Access Compliance Report

Public Rights-of-Way

(Pedestrian Signals)

Intersection ID: N/A	Main Street:	Cross Street: N/A	Location: N/A
ADA ID: F2D9B5A7270A	Signal Type: One Push Button-APS	Overall Compliance: No	Severity Score: BTN 1: N/A BTN 2: N/A No BTN: N/A
Codes/Mitigation Info/Possible Solution		Field Measurements/Component Compliance

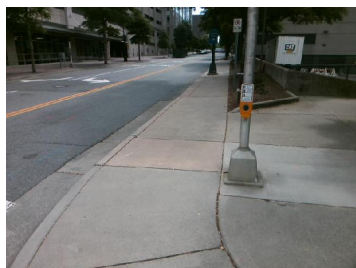
Surveyor Notes: TEXT HT 1/4

PROW/ADA: R410.6, TMUTCD 4e.08, R404.2, R406.2, R209.1, MUTCD 4e.10

Possible Solutions: Replace Signal Push Button With APS Button on New Post. Remove & Replace Sign.
